Date: June 16, 2011  
From: CIET  
Subject: Modification of Cascadia Deployment Plan

The purpose of this memo is to seek approval regarding a change in the Year 1 Cascadia Initiative deployment plan.

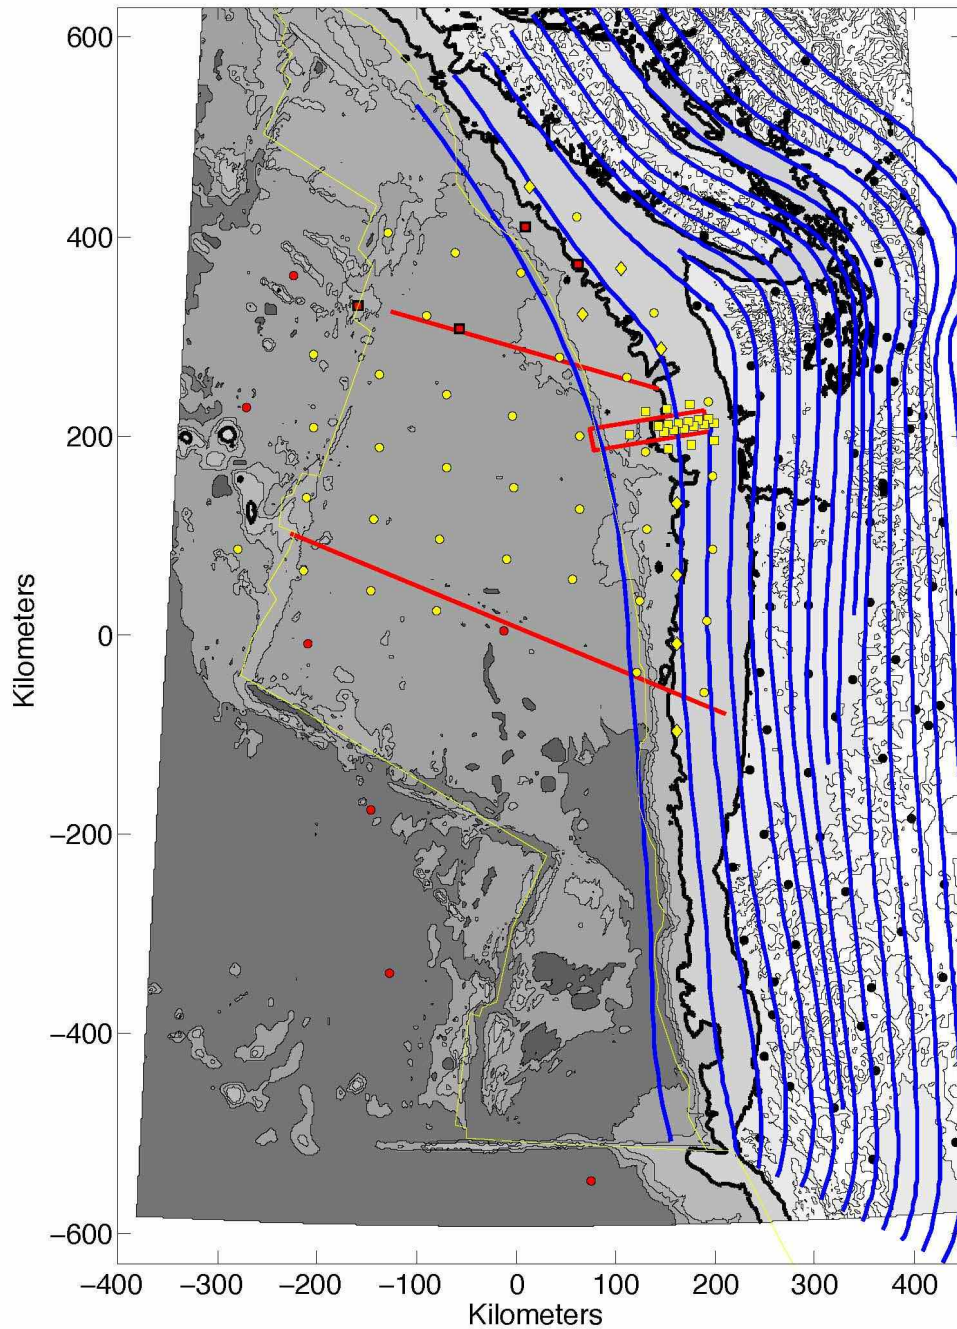
This change in instrument availability requires a change in the deployment plan as discussed at the Portland meeting in 2010 and presented in the workshop report<sup>1</sup>. The TRM OBSs are only suitable for deployment in water depths less than 1000 m. Fig. 1 shows the Year 1 deployment plan from the Portland workshop. Removal of 10 OBSs from the Year 1 deployment plan by necessity impacts either the Northern Focused Array (FA) off of Grays Harbor (yellow squares, Fig. 1) or the along-strike coverage and monitoring of the forearc.

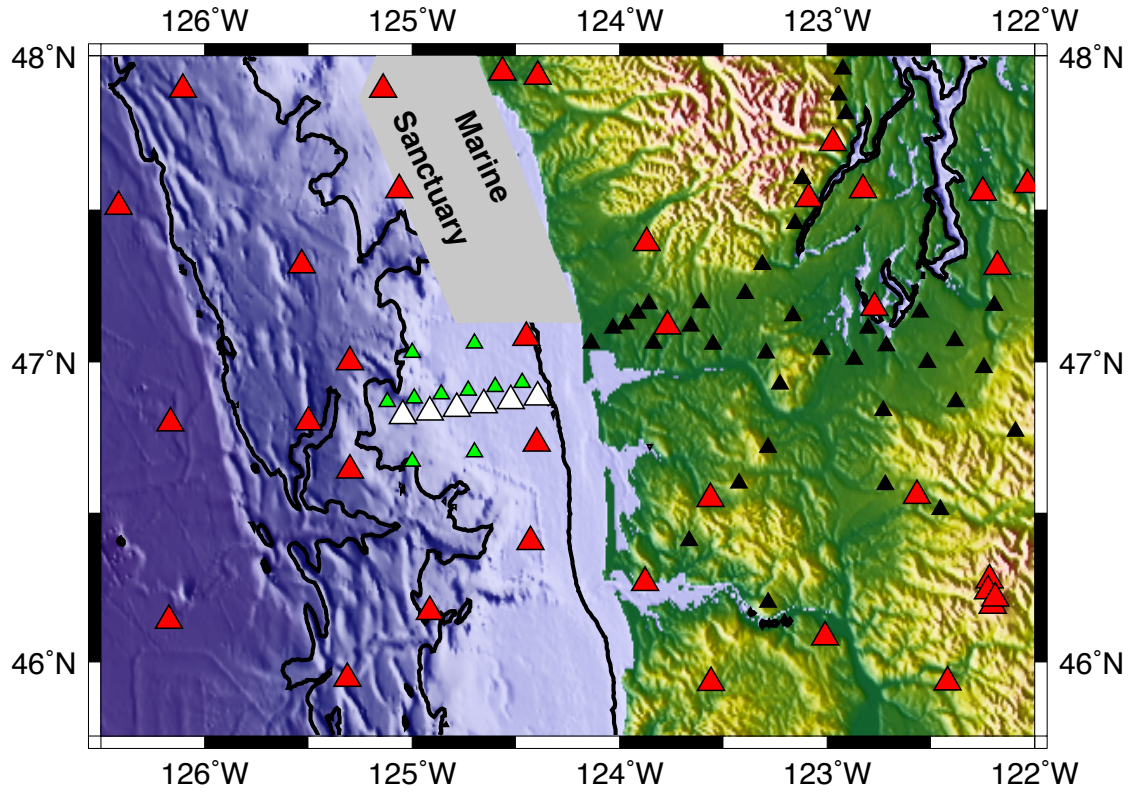
In view of the above, the CIET requests that AASC approve the following modification to the Year 1 deployment plan. A total of 10 instruments from the Northern Focused Array will be assigned a lower priority for deployment in 2011 (i.e., unless we get lucky,

these 10 OBS will not be deployed this year). Figure 2 shows a revised deployment plan in the vicinity of the Northern FA under the assumption that 10 TRM OBSs are available and that 2 of these 10 instruments are targeted for monitoring along the shelf (see Fig. 3). A line with cross-strike aperture has been maintained in the Northern Focused Array. If this general plan is approved, minor adjustments to site location will be made to achieve uniformity of spacing along the forearc and to take into consideration bathymetry, trawling activity and geo/bio-hazards. The proposed changes do not adversely affect the monitoring of the forearc and the data to be collected by the Northern FA will provide a good opportunity to evaluate the potential of the receiver function method in shallow water environments.
